# VICTORIA CROSS

OVER STATION DEVELOPMENT  
NORTH SYDNEY

DETAILED STATE SIGNIFICANT DEVELOPMENT APPLICATION

RESPONSE TO SUBMISSIONS

# BUILT FORM AND SETBACKS VIEW ANALYSIS THE MILLER

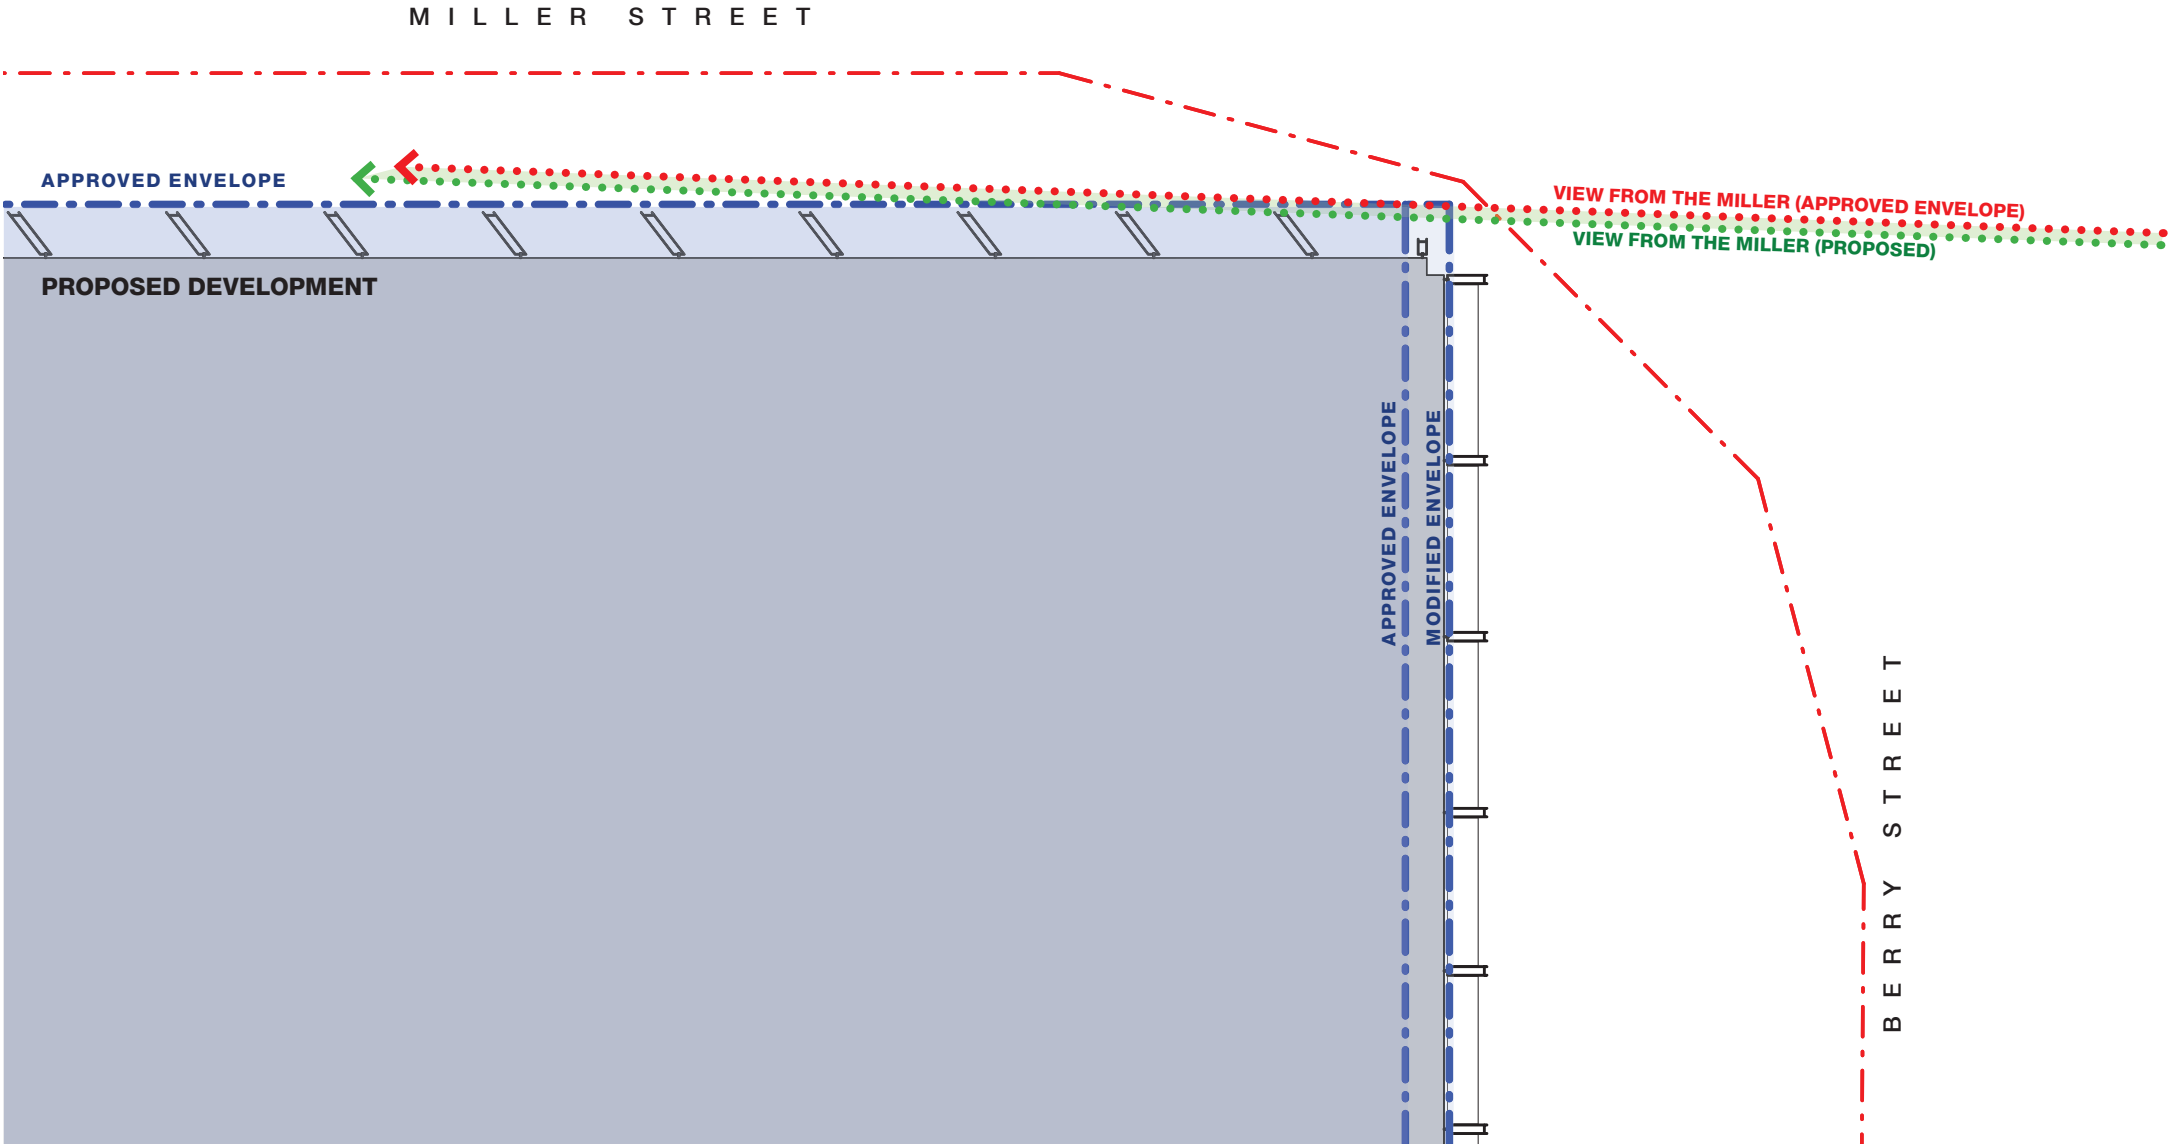
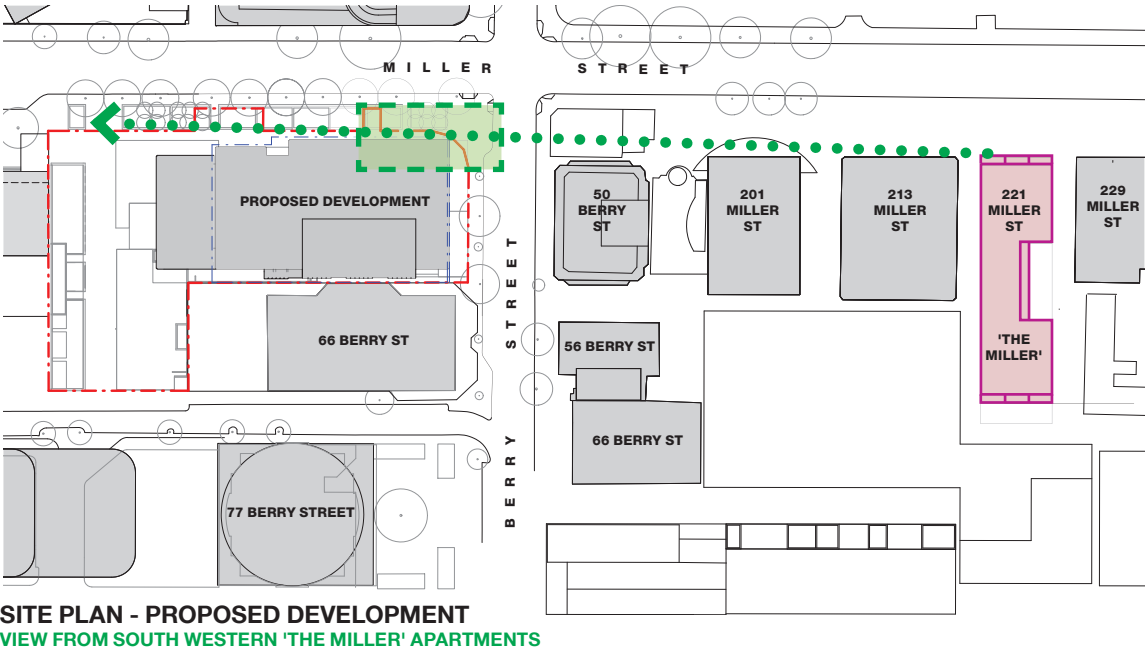
/ MAJOR VIEW LOSSES TO ALL NEW APARTMENTS WITHIN 221 MILLER STREET  
“THE MILLER” HAS NOT BEEN CONSIDERED AND NEEDS TO BE INDIVIDUALLY  
ADDRESSED. - ‘PUBLIC’

This page shows the increase in view outlook to the south west  
achieved from the balcony of west facing apartment of 'The Miller'  
Apartments.

In conclusion the proposed development maintains and improves the  
general south west outlook view corridor from The Miller Apartments  
compared to the approved envelope.

# BUILT FORM AND SETBACKS VIEW ANALYSIS THE MILLER

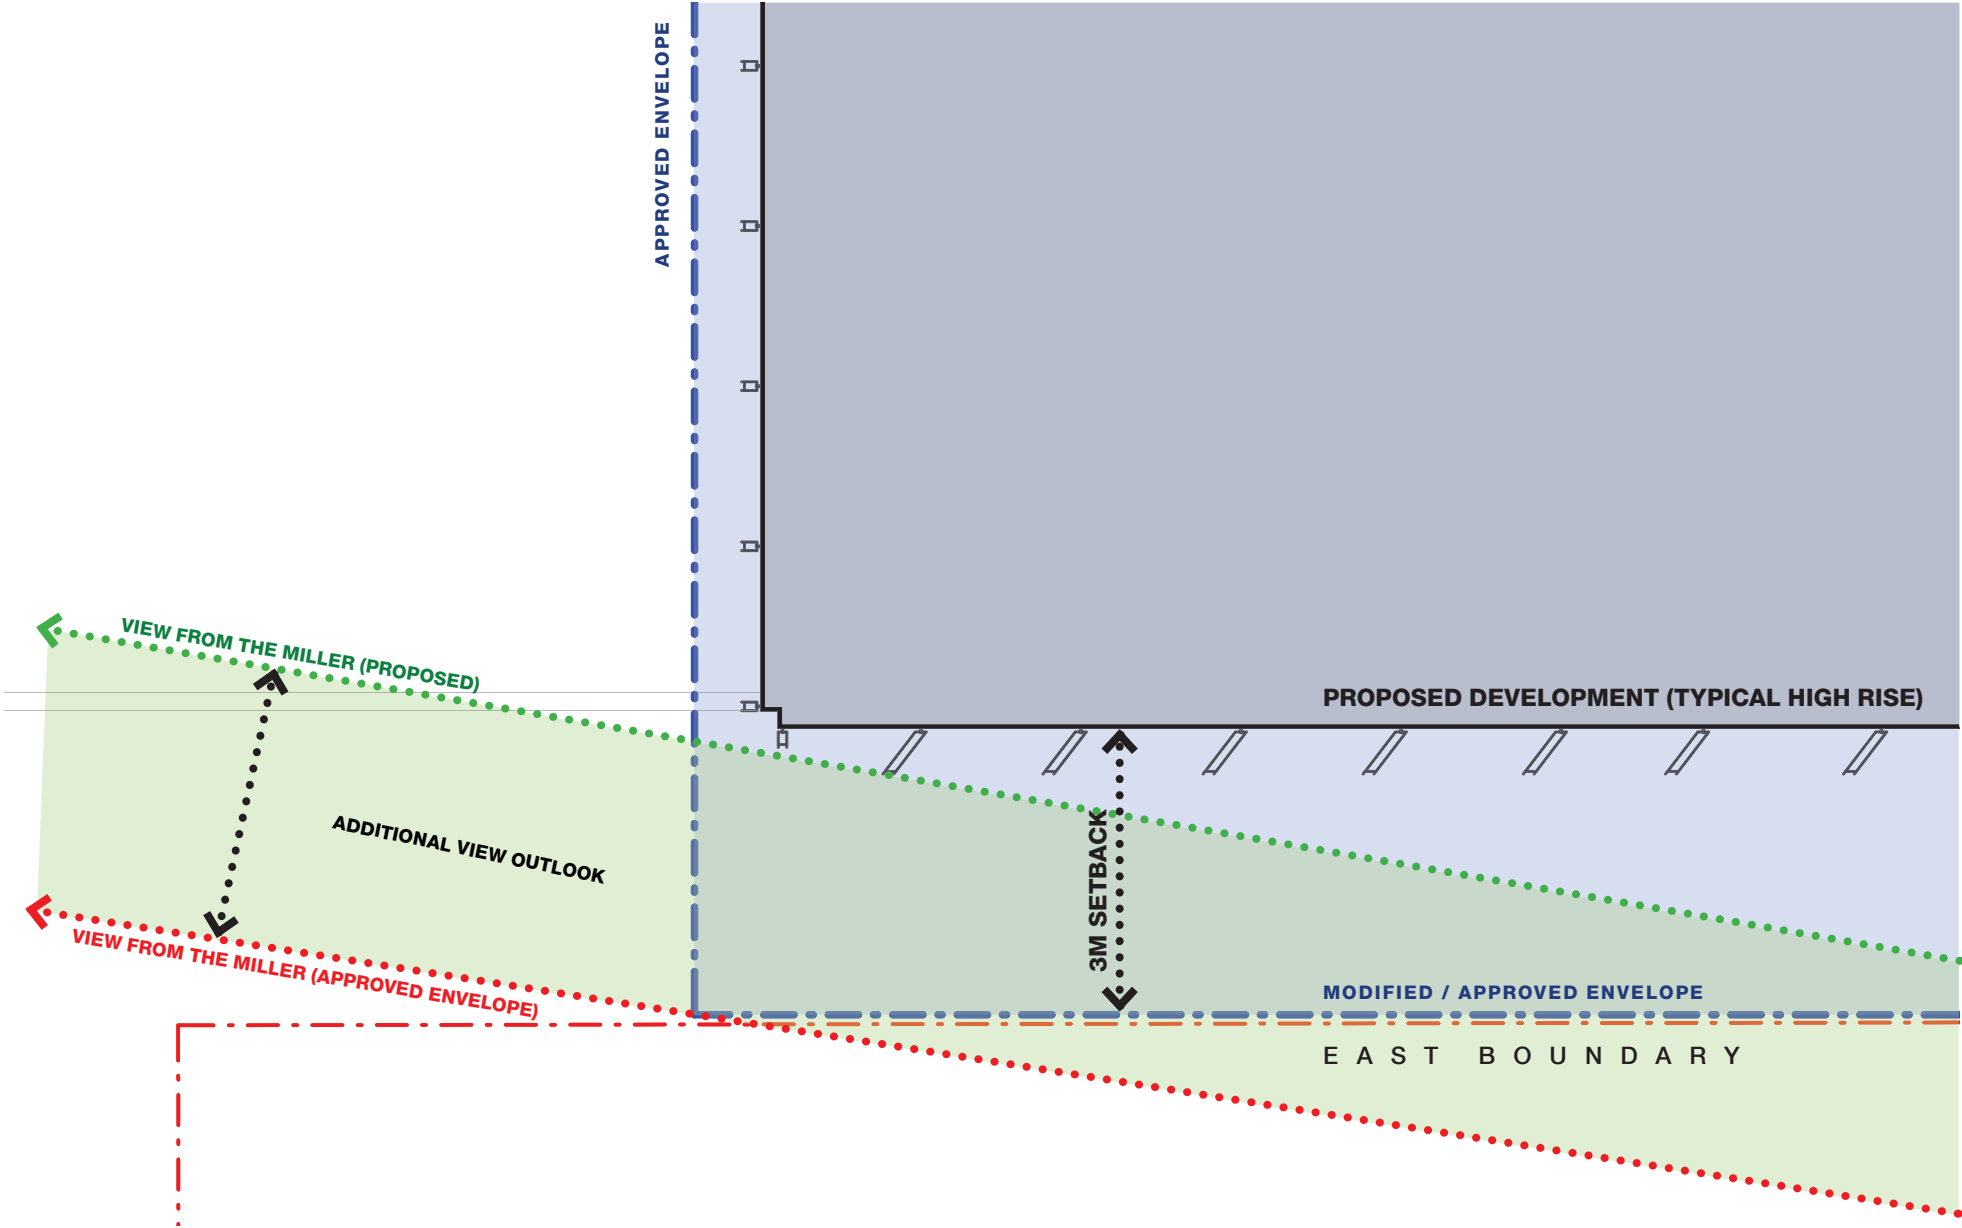
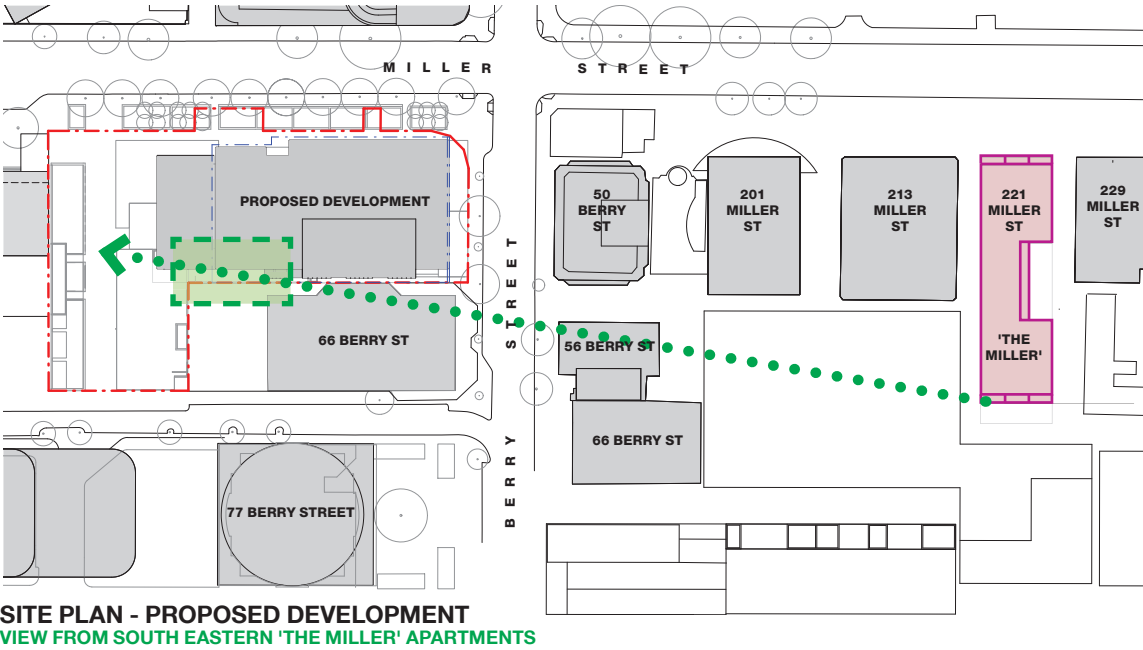
/ MAJOR VIEW LOSSES TO ALL NEW APARTMENTS WITHIN 221 MILLER STREET  
“THE MILLER” HAS NOT BEEN CONSIDERED AND NEEDS TO BE INDIVIDUALLY  
ADDRESSED. - ‘PUBLIC’

This page shows the increase in view outlook to the south west  
achieved from the balcony of east facing apartments of The  
Miller Apartments.

In conclusion the proposed development achieves an  
additional 3m setback to the eastern boundary and improves  
solar access and general outlook from The Miller Appartments  
compared to the approved building envelope.

## VIEW ANALYSIS ALEXANDER APARTMENTS

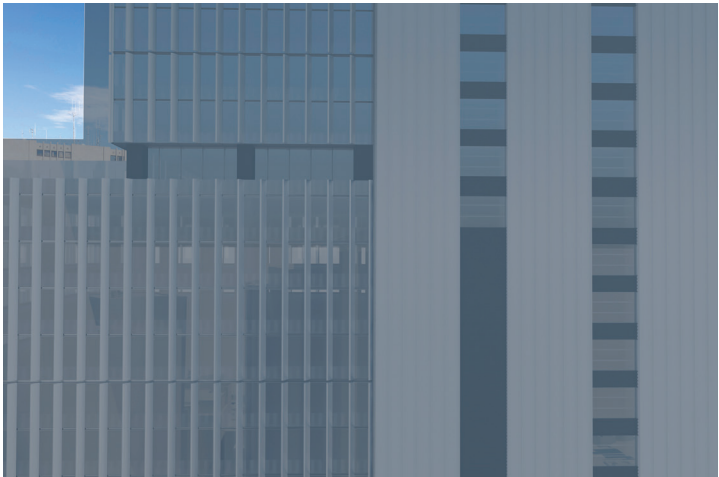
/ THE PROPOSED MODIFICATIONS TO THE BUILDING ENVELOPE AND DISTRIBUTION  
OF MASSING IN RELATION TO THE VIEW LOSS AND AMENITY CONCERNS RAISED IN PUBLIC SUBMISSIONS - DPIE

**VIEW IMPACT AT RL 174.05 (LEVEL 37)**  
At RL 174.05, the proposed SSDA building does not obscure either views to the MLC building or to Sydney Harbour
